V0_1: First 2020 ver. Prototype
V0_2:
Adding Mivromatch header for comms with System Controller.
Adding ground connection for differential input to ADC.

DUAL RAIL POWER SUPPLY

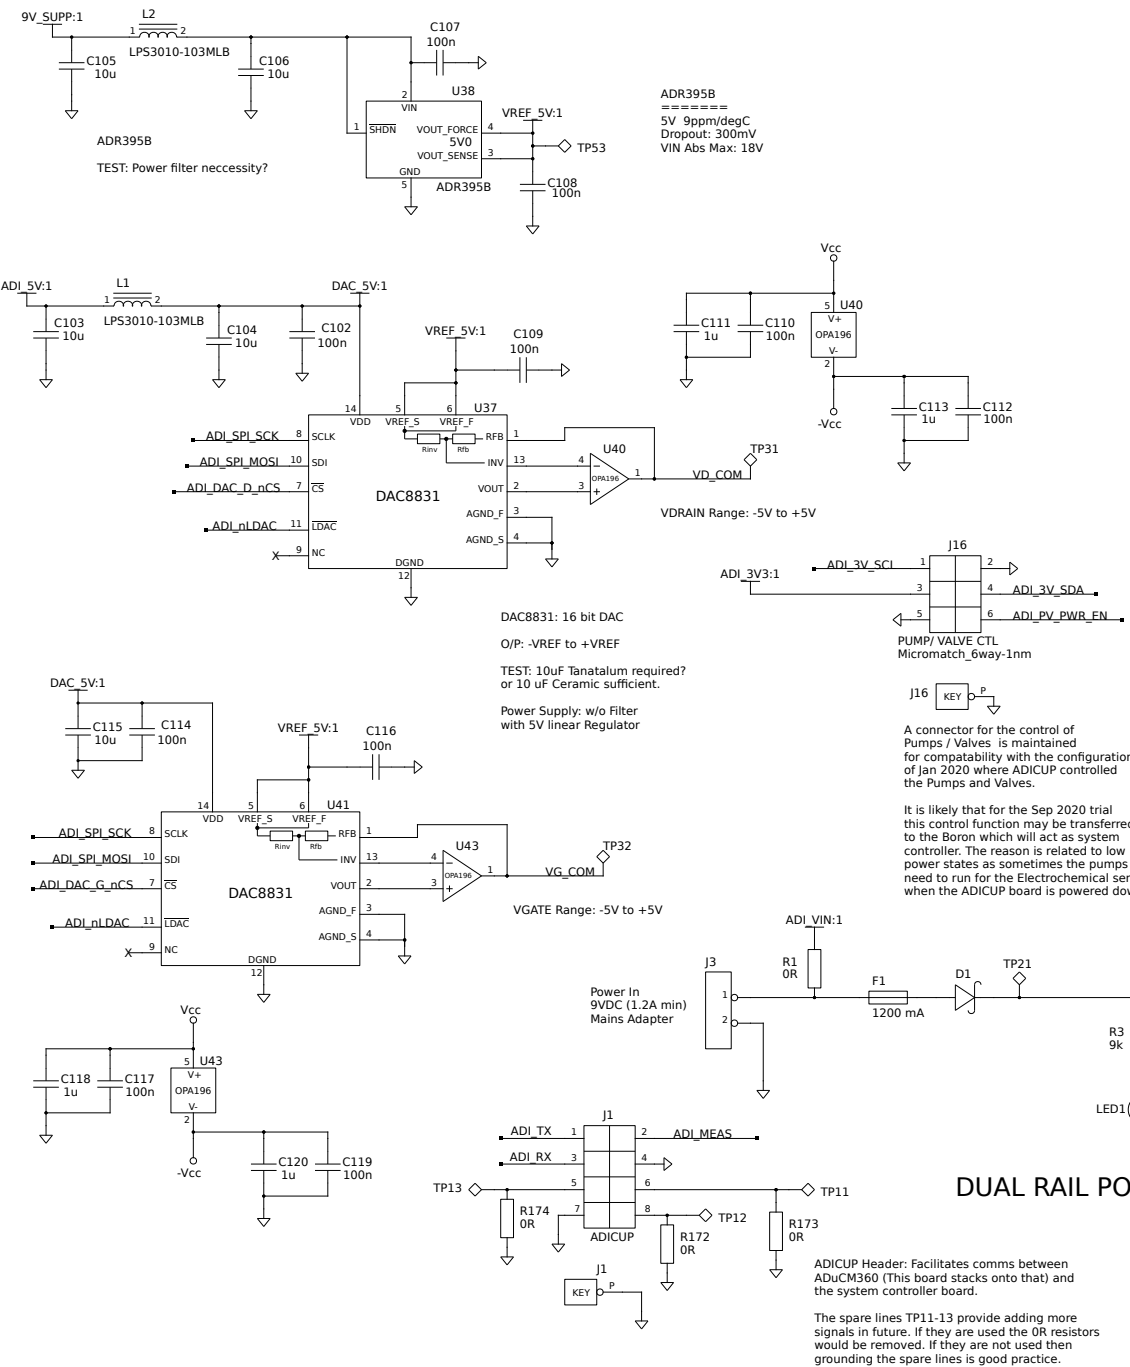
REVIEW:
Consider reducing opamp supply rail voltages considering that bias voltages now only need to go up to +/- 5V.
